Figure 1-8.

Well R-16 Schlumberger Geophysics of Screen #4.
Permeability increases from left to right on the figure.

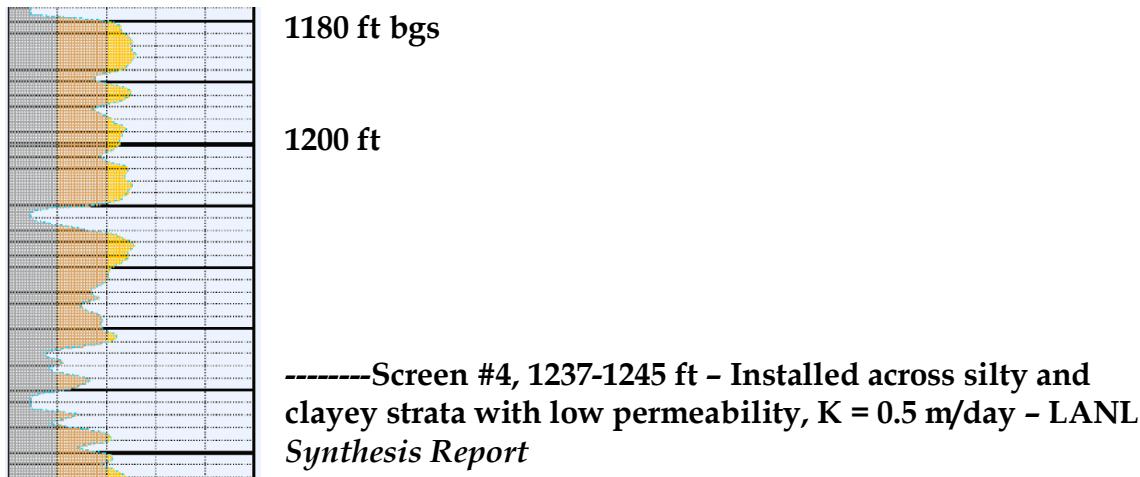
Strata with markedly higher permeability are at a depth of 1180 to 1188 feet and at a depth of 1252 to 1262 feet below ground surface (bgs).

- Also, Screen #4 is surrounded by Bentonite Clay Slough that was not cleaned out of the borehole
- Well R-16 was drilled with the Conventional Mud Rotary Method.

- All of the screened intervals are invaded with large quantities of Bentonite Clay Drilling Mud and Organic Additives. None of the Screened Intervals in LANL Well R-16 meet the requirements of RCRA Subpart F.

- All of the drill cuttings produced from the mud rotary borehole are mixtures of cuttings from different depths as the cuttings travel out of the borehole along the borehole wall. Furthermore, all of the drill cuttings were contaminated with the bentonite clay drilling mud.

- The contaminated and mixed drill cuttings are not useful for identifying the strata with highest permeability that are appropriate for monitoring
- The borehole geophysics were the best information for locating the well screens in well R-16 but the Schlumberger report shows that the well screens are not installed in the aquifer strata that are important for long-term monitoring.

- There is a need to install a new monitoring well near the location of well R-16 to monitor the aquifer strata that may form a pathway for contamination from LANL to travel beneath the Rio Grande to the Buckman Well Field, and important water supply for Santa Fe.
